To: Plan Holders for SLN Terminal Expansion  
Salina Regional Airport  
Salina, KS  
AIP Project Number 2-20-0072-054/055-2024

Transmitted herewith Addendum No.2 to the Issued for Bid Contract Documents, Specifications and Plans dated July 2, 2024 for improvements to the Salina Regional Airport.

**ADDENDUM NO. 3**  
**TO**  
**CONTRACT DOCUMENTS, TECHNICAL SPECIFICATIONS, AND**  
**PLANS**  
**FOR IMPROVEMENTS TO THE**  
**SALINA REGIONAL AIRPORT**  
**SALINA, KS**  
**AIP PROJECT NUMBER 2-20-0072-054/055-2024**

SHEET NO:  
**S2.02**

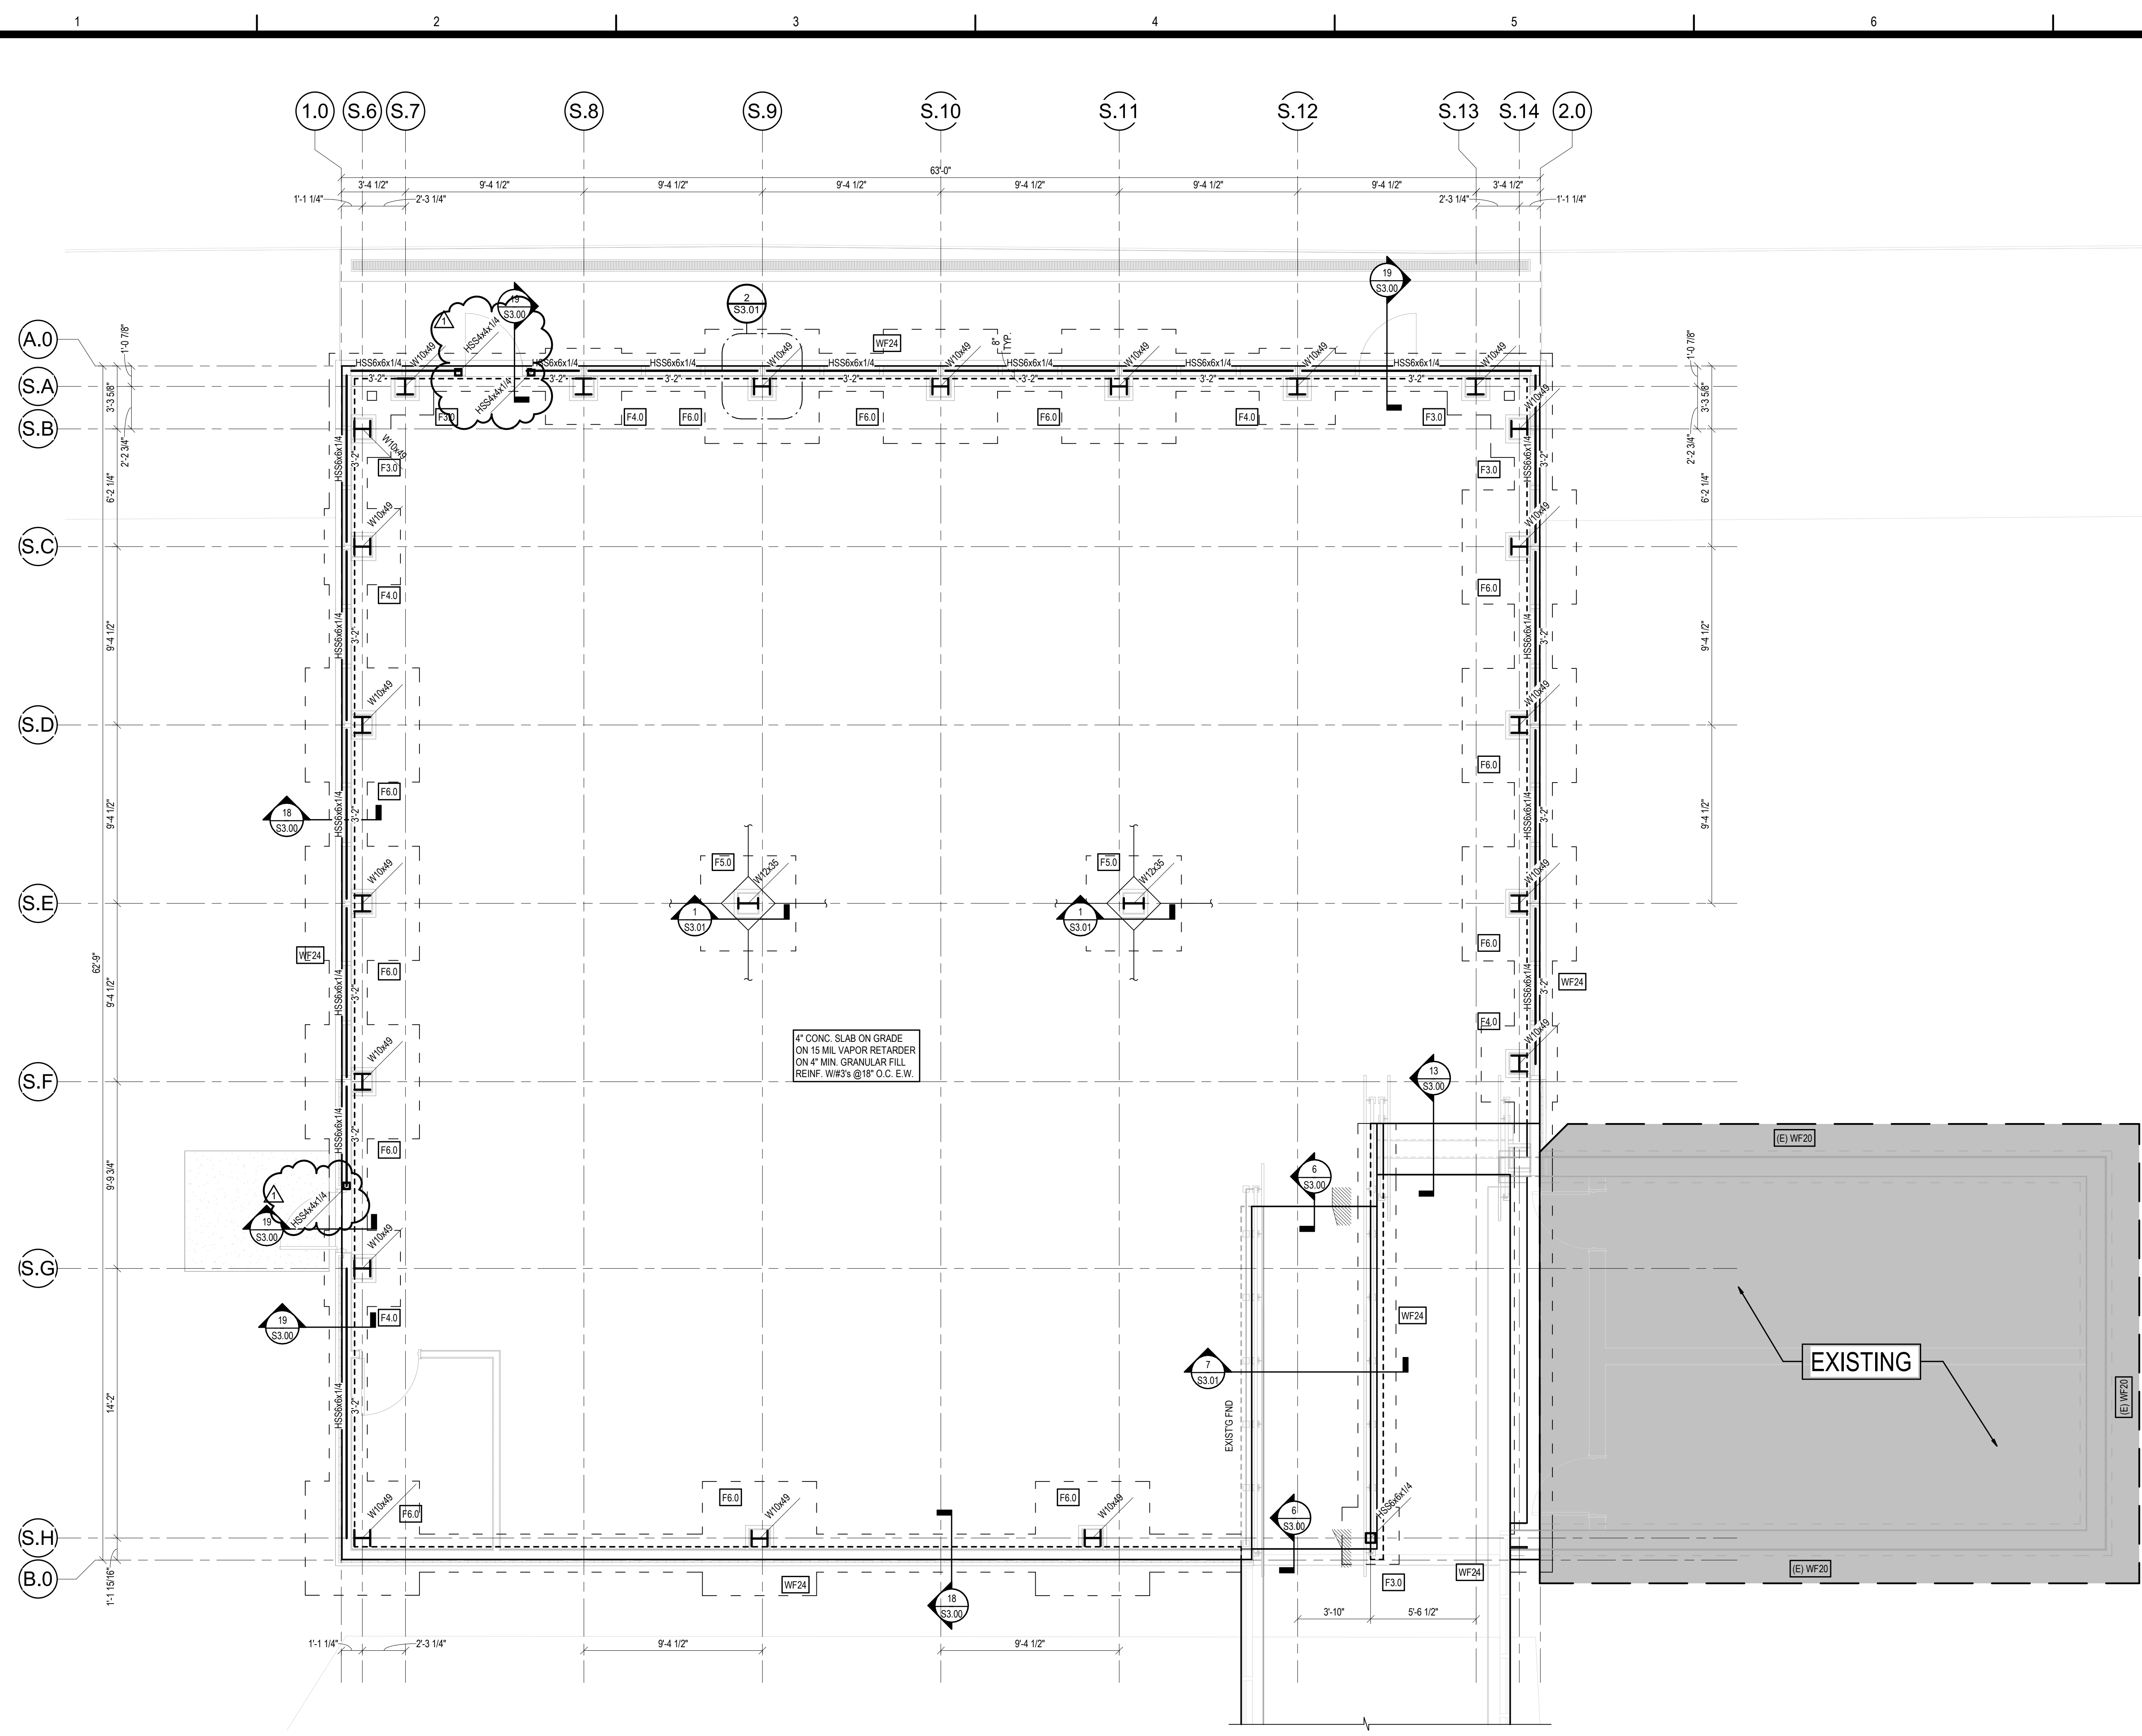
**S202 CHECKPOINT FOUNDATION PLAN**

**Justification:** For clarification of footings.

8. *Footing schedule is missing from the plans. Can this please be provided?*  
**RESPONSE:** Please see the added Footing Schedule on Structural Sheets.

SHEET NO:  
**S2.03**

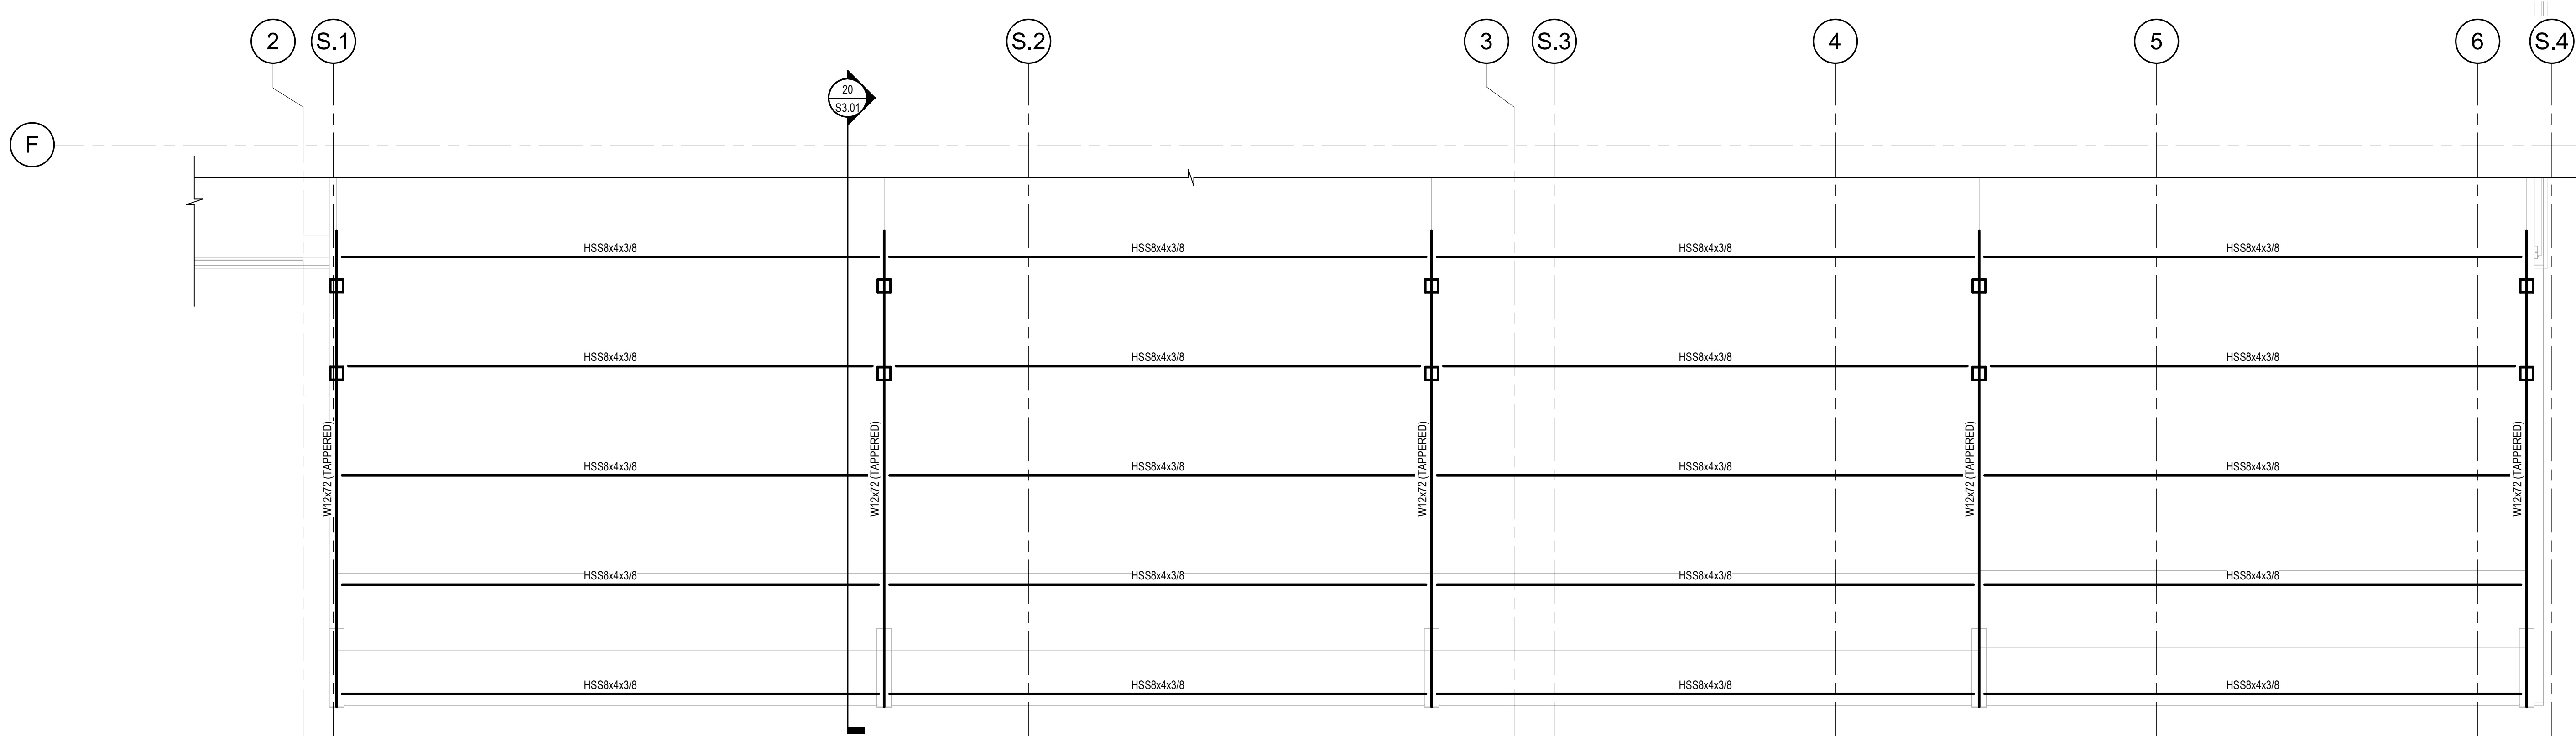
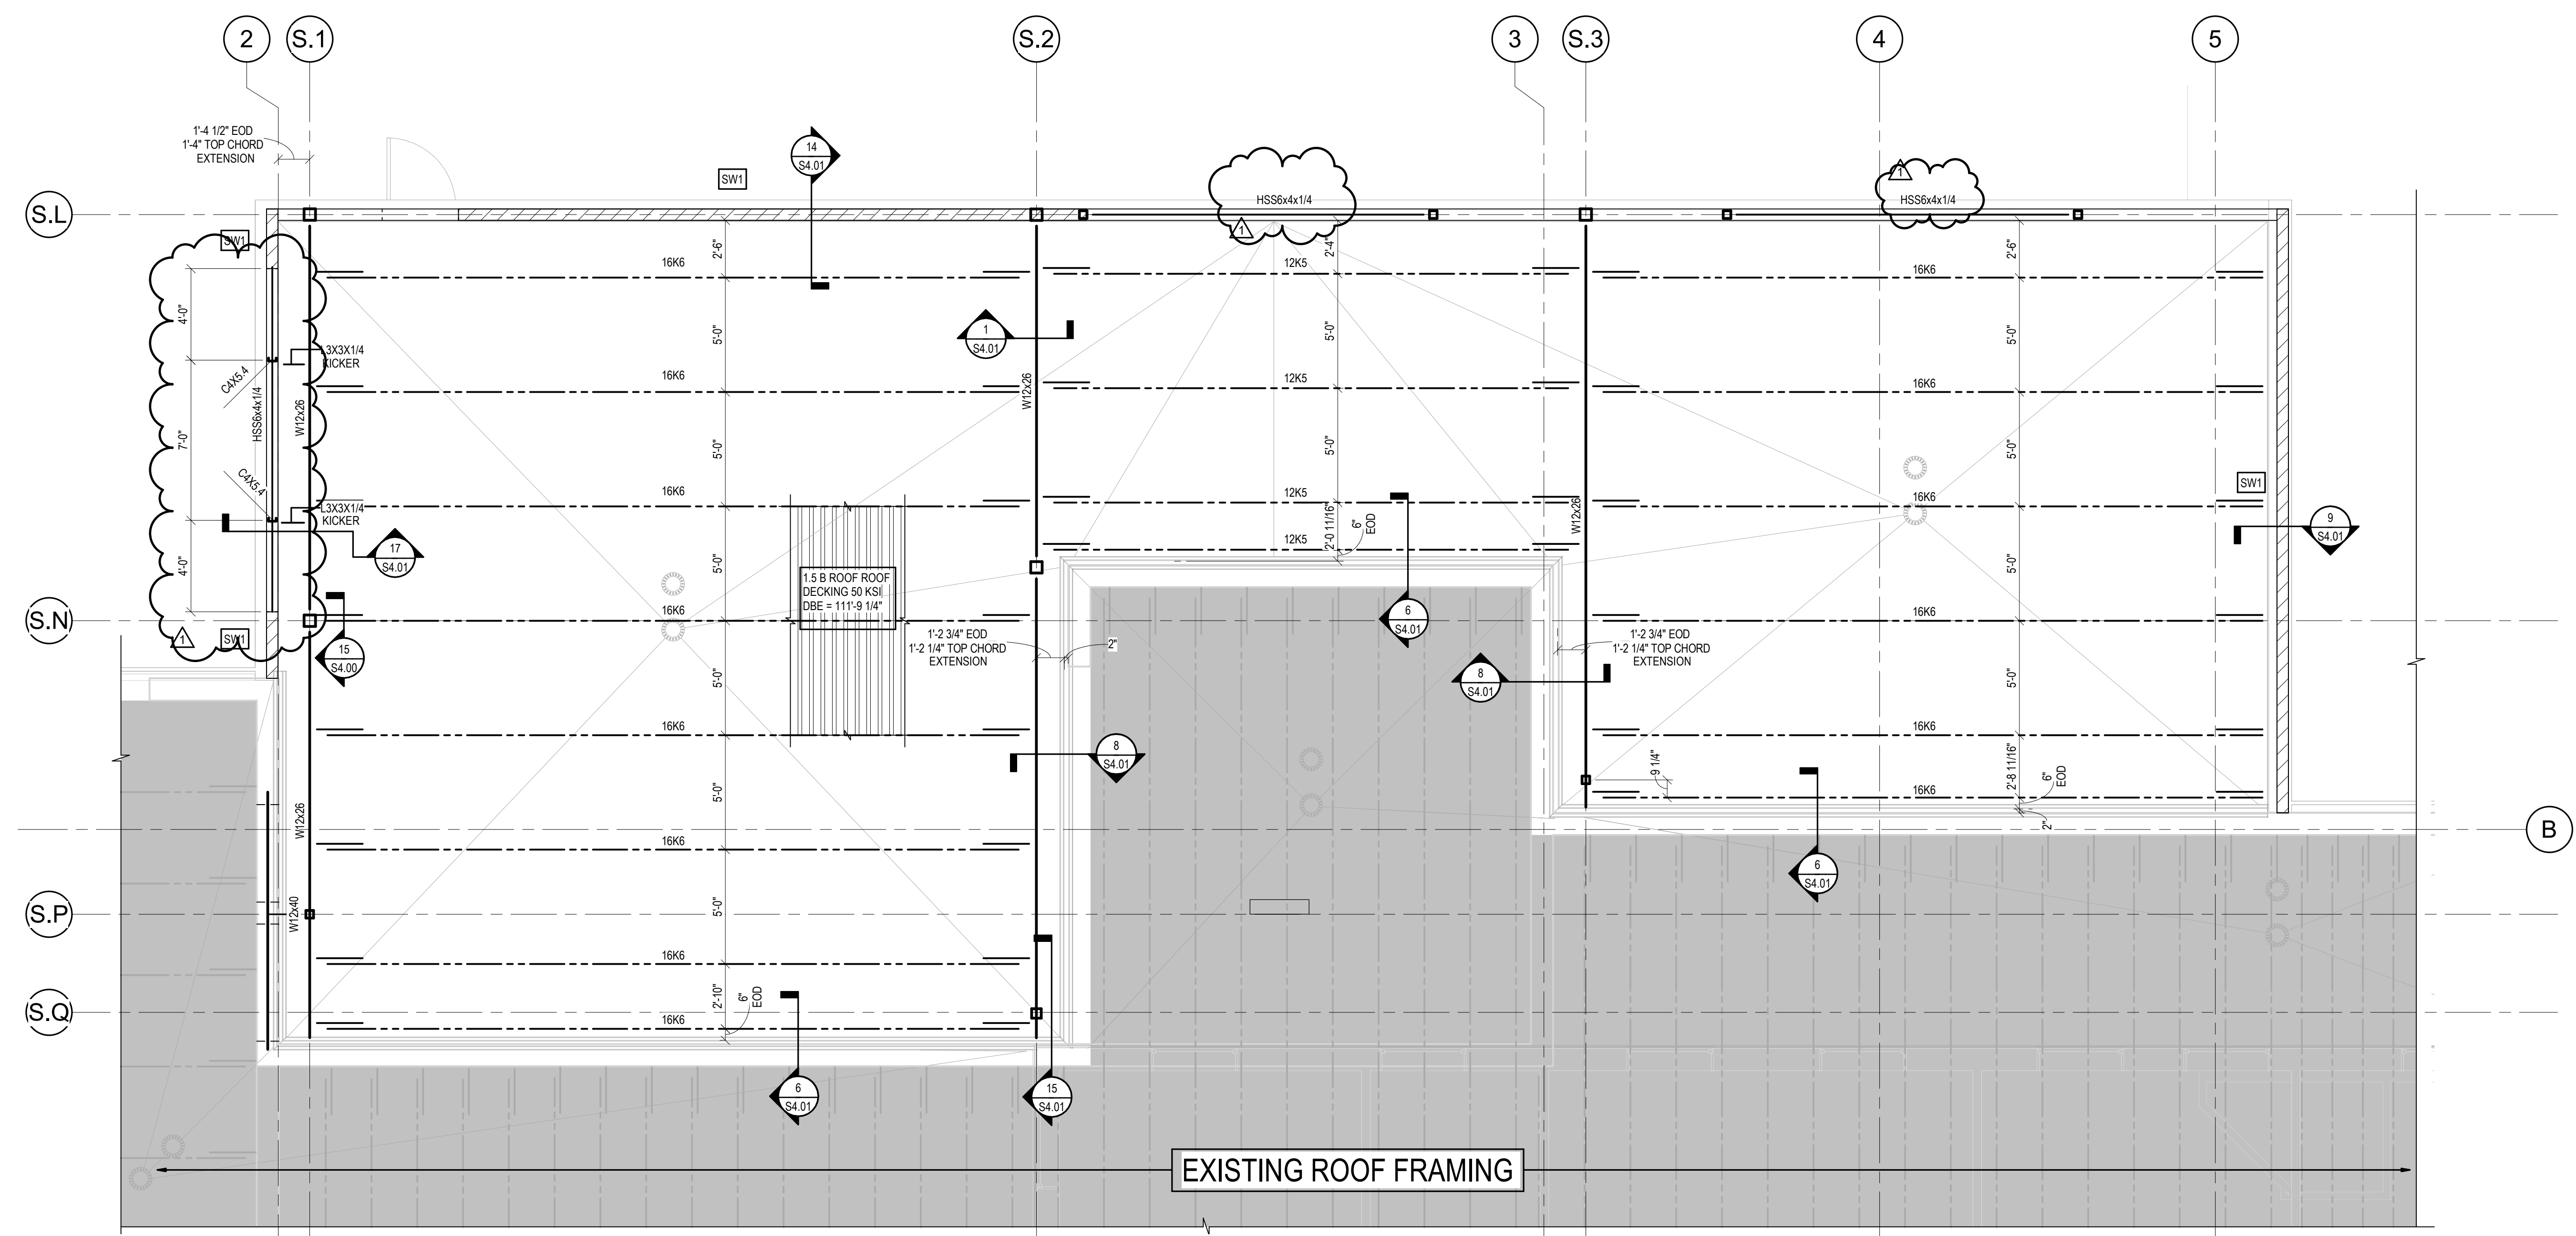
**S203 HOLD ROOM FOUNDATION PLAN**

**Justification:** For clarification of footings.
